**Proposal for amendments to the Consolidated Resolution
on the common specification of light source categories (R.E.5)**

Proposal for Amendment 11 to the Consolidated Resolution on the common specification of light source categories (R.E.5)

Submitted by the Working Party on Lighting and Light-Signalling*

List of sheets for LED light sources and their sequence, amend to read:

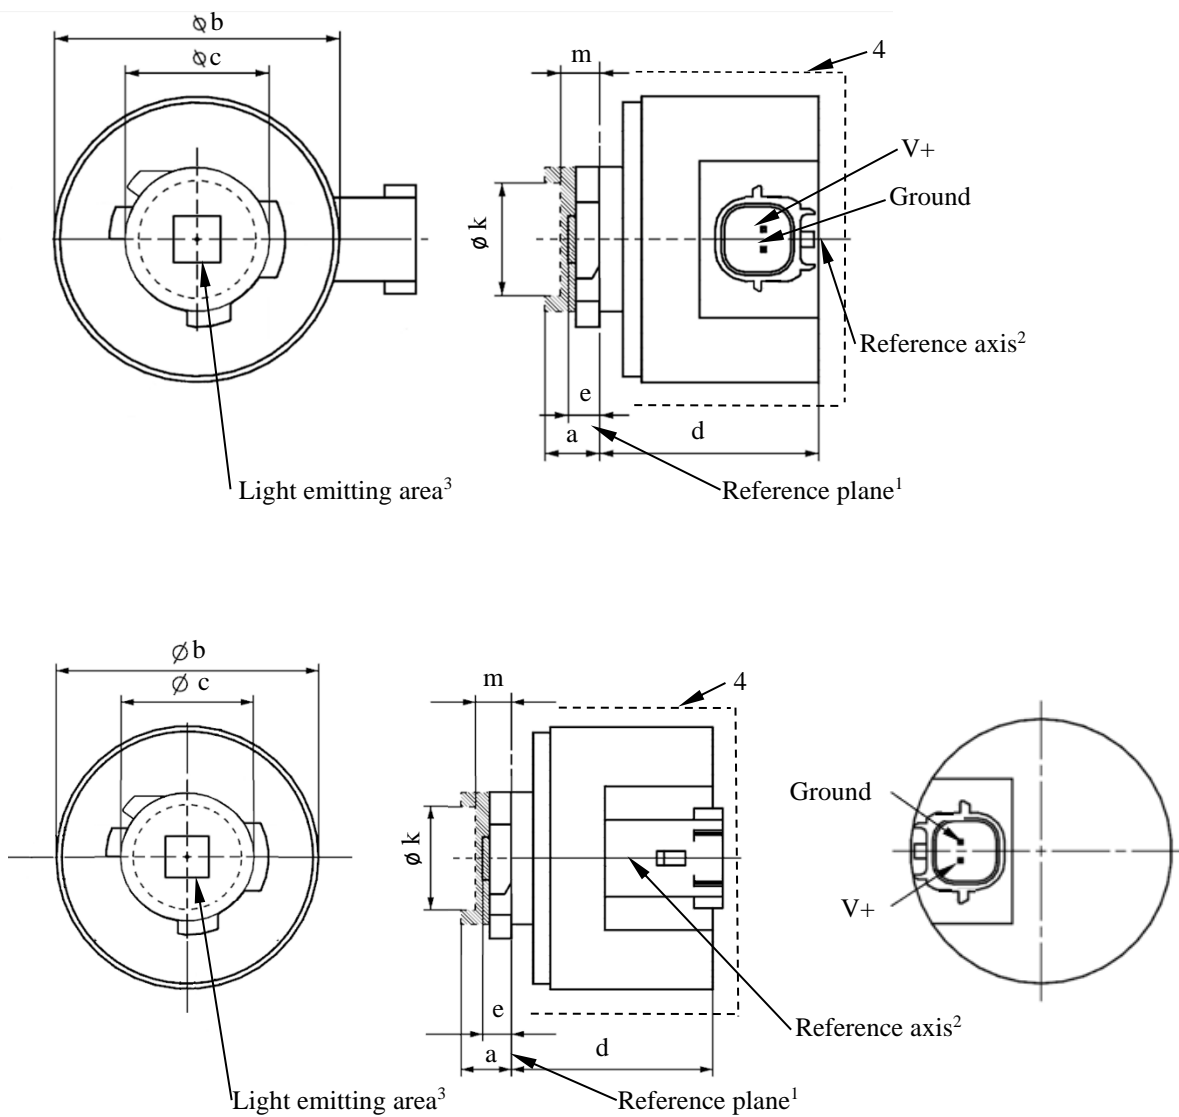
Annex 3,

<i>Sheet number(s)</i>
C5W/LED/1 to 4
C5W_LED/1 to 4
H11/LED/1 to 7
H11_LED/1 to 7
L1/1 to 5
LR1/1 to 5
LW2/1 to 5
Lx3/1 to 6
LR4/1 to 5
Lx5/1 to 6
Lx6/1 to 6
Lx7/1 to 6
PY21W/LED/1 to 4
R5W/LED/1 to 4
W5W/LED/1 to 4

Figure 2

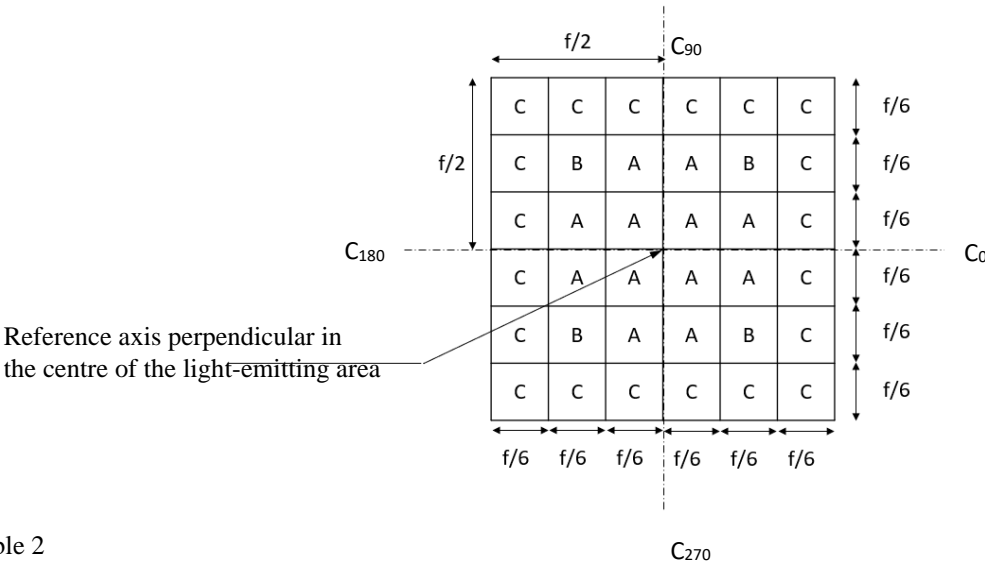
*After sheet Lx6/6, insert new sheets Lx7/1 to 6, to read
(see the following pages; one page per sheet):*

The position of the light emitting area is checked by the box system defined in Figure 2, which is aligned to the planes C_{90} and C_{180} and shows the projection when viewing along direction $\gamma = 0^\circ$ at $e = 3.0$ mm (C, γ as defined in Figure 3). The luminous flux Φ emitted into the viewing direction shall be calculated as given below:

The distribution of luminous flux originating from the LEA as shown in Figure 2 shall fulfil the requirements given in Table 3. All numbers shall be given in % of the total luminous flux emitted into the viewing direction from the bayonet core area, i.e. a circular area with diameter $c = 18.5$ mm (see Figure 1).

Box definition of the light emitting area with dimensions as specified in Table 2
